Title of Change:	AR0521 Datasheet Update
Effective date:	03 Jul 2020
Contact information:	Contact your local ON Semiconductor Sales Office or Sonya.Yip@onsemi.com
Type of notification:	This Product Bulletin is for notification purposes only. ON Semiconductor will proceed with implementation of this change upon publication of this Product Bulletin.
Change Category:	Documentation Change
Change Sub-Category(s):	Datasheet/Product Doc change

AR0521 Datasheet Changes**1. Updated Figure 3, "Typical Configuration: Serial Four-Lane HISPI Interface" Notes****Old Figure 3:**

Figure 3. Typical Configuration: Serial Four-Lane HISPI Interface

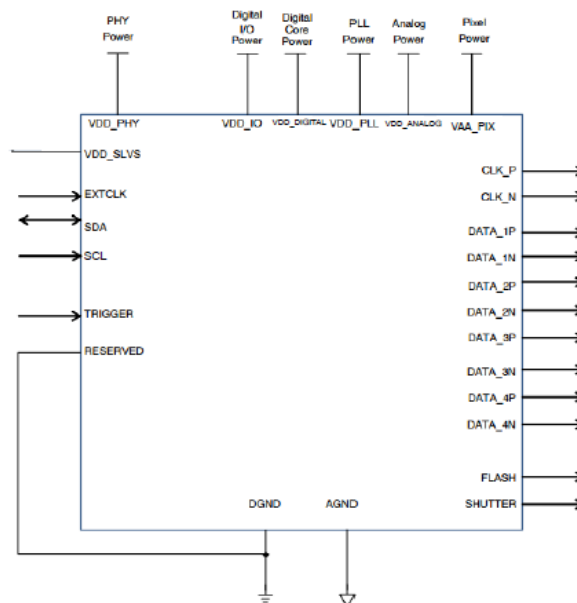
1. If using an internal regulator, leave VDD_SLVS floating and set R0x31BC[13]=1 and R0x31BE[3:2]=0
2. If connecting DVDD_SLVS to 0.4V external power supply, set R0x31BC[13]=0 and R0x31BE[3:2]=1

Figure 3. Typical Configuration: Serial Four-Lane HISPI Interface

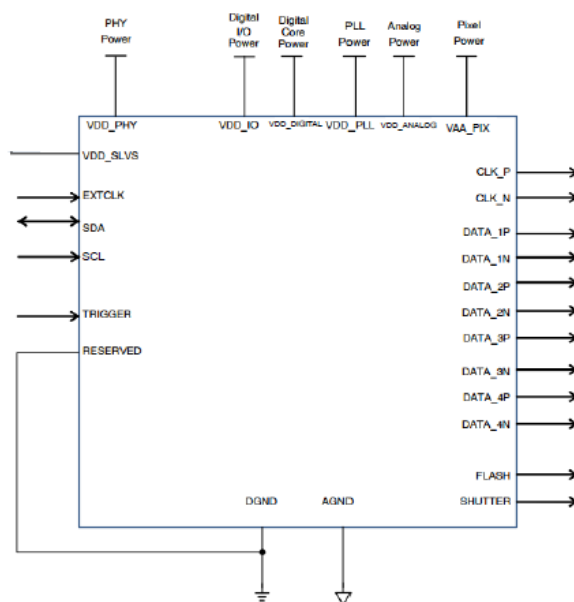
New Figure 3:

1. If VDD_SLVS uses the internal regulator, decouple VDD_SLVS with a 0.1 μ F ceramic capacitor to DGND and set R0x31BC[13]=1 and R0x31BE[3:2]=0.
2. If VDD_SLVS uses 0.4 V external power supply, set R0x31BC[13]=0 and R0x31BE[3:2]=1.
